APPENDIX A

**PUBLIC COMMENT MATRIX
AND CORRESPONDENCE**

COMMENT MATRIX
FROM PUBLIC SCOPING MEETING APRIL 27, 2016

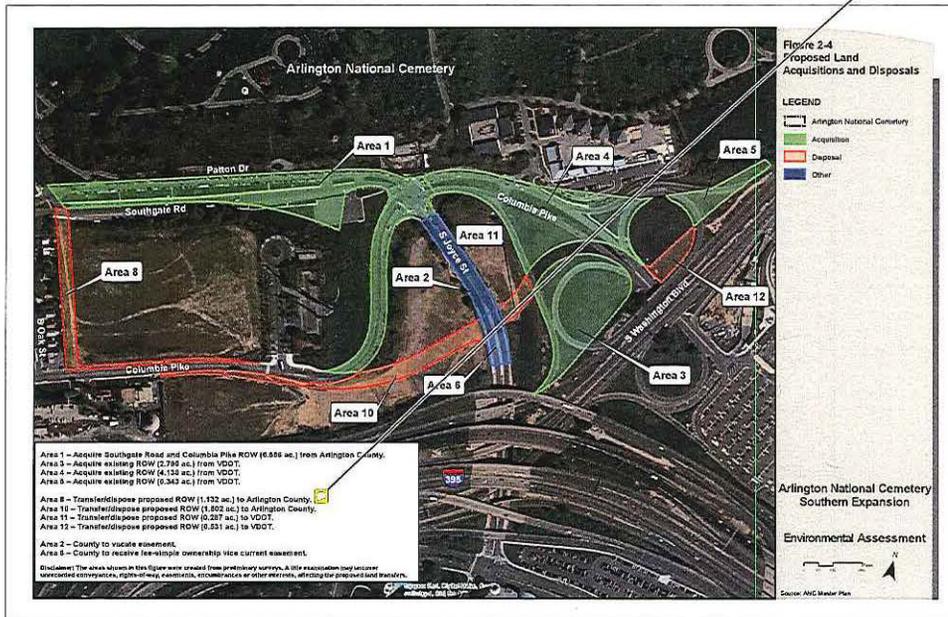
Author: sfinotti Subject: Sticky Note Date: 09/21/2018 4:12:32 PM
